Environmental Assessment Report

Section 75W Modification Application

Central Park, Broadway

Modification to Approved Concept Plan MP 06_0171 (Mod 8)

Figure 2 – Amended Public Domain Plan

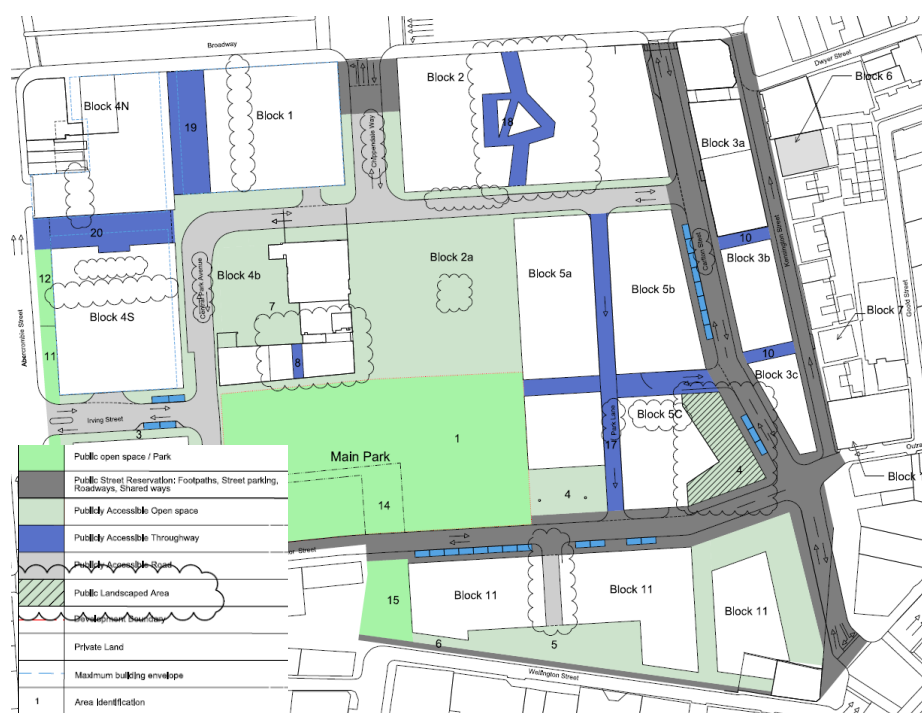
Figure 2 shows the revised Public Domain Plan. Some minor modifications have been made to reflect the revised design of Blocks 1, 4N and 4S. Several other changes are highlighted to pick up modifications which have been approved as part of separate Project Applications, including minor changes to Block 2 and the Brewery Yard. This includes a modification to the publicly accessible thoroughways between the Clare Hotel and Administration Building on Block 3A. It is noted that the intention of these areas was never to provide a formal through-site link between the buildings, rather, it was imposed to ensure that the Clare Hotel and Administrative Building could be read as two distinct elements (this requirement has been incorporated into the design through the provision of a glazed linking structure). The changes also include a modification to the public domain around Block 5C, which is proposed to change from a publicly accessible open pace, to a public landscaped area. This change has been made in consultation with the City of Sydney Council, in an attempt to discourage antisocial behaviour in this area.

Figure 4 – Proposed Block 1, Block 4N and 4s envelopes

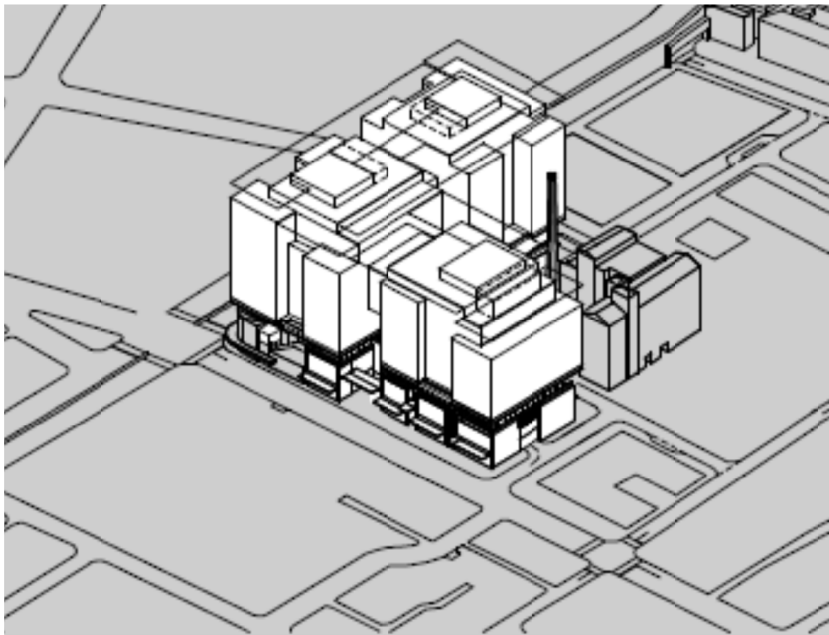
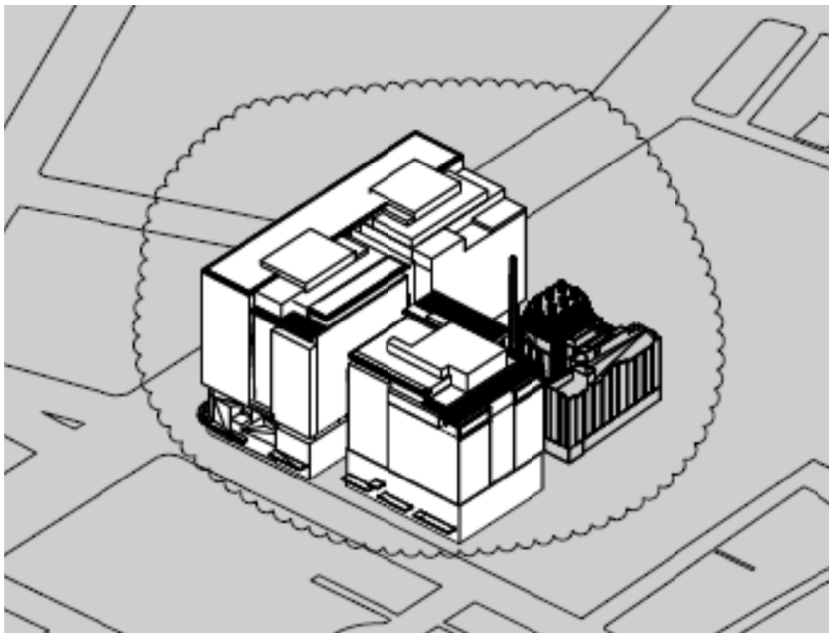
The approved and proposed envelopes for Blocks 1, 4N and 4S are shown at **Figures 3 and 4** respectively. As discussed below, the revised massing remains generally consistent with the Concept Plan approval, and the key design objectives.

The proposed changes to the approved Block 4S envelope will facilitate the change of use from commercial offices to student accommodation. The revised envelope maintains the City Datum Line (with a recessed expression in the envelope that relates to the height of the Australia Hotel) and will ensure that there will be no additional overshadowing of the Main Park or properties along Abercrombie Street at key times of the year.

The changes to the Block 1 and 4N envelope responds to current trends in commercial office design, which typically require a large floor plate with maximum connectivity. The proposed modifications will enable more efficient floor plates, and a massing that is more sympathetic to the adjoining Block 2 development, whilst maintaining the key concept of the City Datum Line, which has been maintained around the perimeter of both Block 1 and 4N.

Further, the proposed modifications to the Block 1 and 4N envelope are accommodated within the approved height, and do not affect shadows cast across the Main Park. This has been achieved by ensuring that the revisions to the massing of the northern elevation are contained within the underside of the approved solid canopy.
